Application No. 10/693479 Amendment dated January 26, 2006 Reply to Office Action of July 26, 2005

AMENDMENTS TO THE DRAWINGS

The Office Action noted that Figures 1-5 should be designated by a legend such as -- Prior Art --. This has been done. Review and approval of the proposed drawing correction is respectfully requested.

Fig. 5 (PRIOR ART)

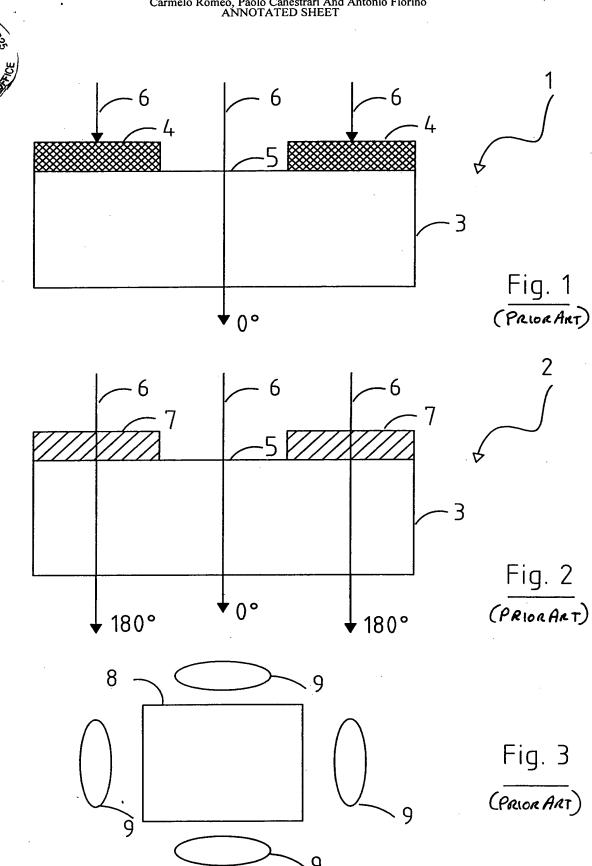
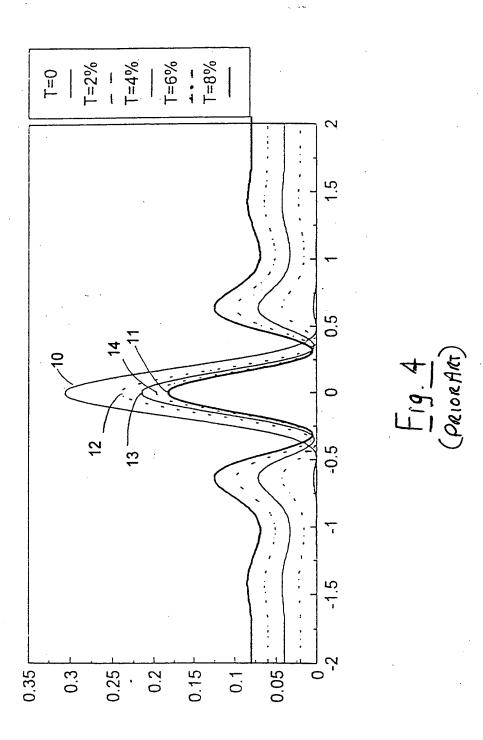
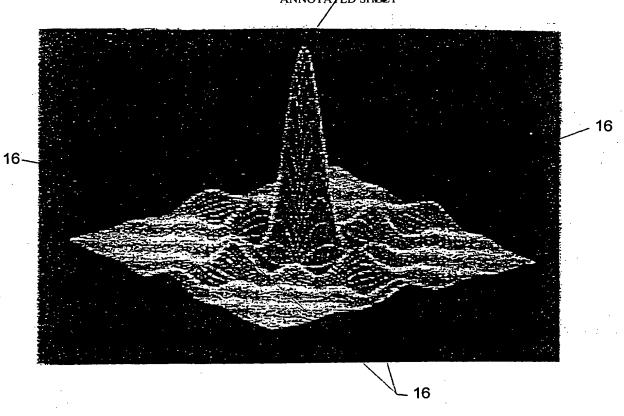
The Office Action indicates that Figs. 1-5 should be designated by a legend such as --Prior Art--. The drawings have been so corrected. Review and approval of the corrected drawings is respectfully requested.

"Replacement Sheet" is attached which includes a clean version of amended Figures 1 through 5. The attached sheet replaces the original sheet including Figures 1-5.

"Annotated Sheets Showing Change" is also attached which includes a marked-up version of Figures 1-5.
